Transmission Expansion Advisory Committee DEOK Supplemental Projects

September 18, 2026

Cancellations

Need Number: DEOK-2025-006 (Cancellation)

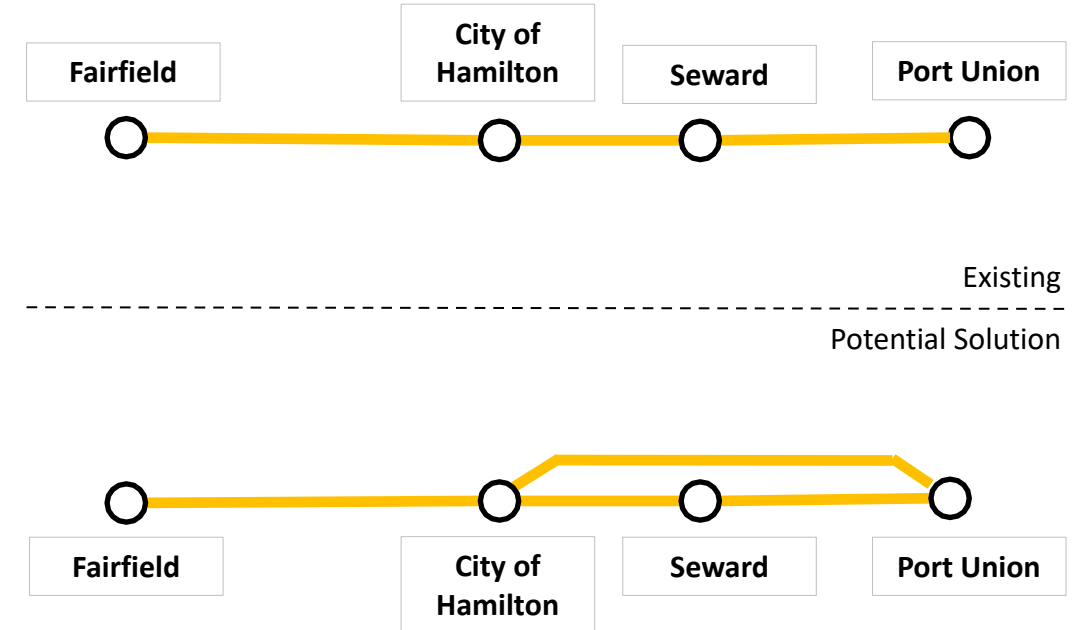
Reason for Cancellation:

Customer has withdrawn their load request, cancelling this need and solution.
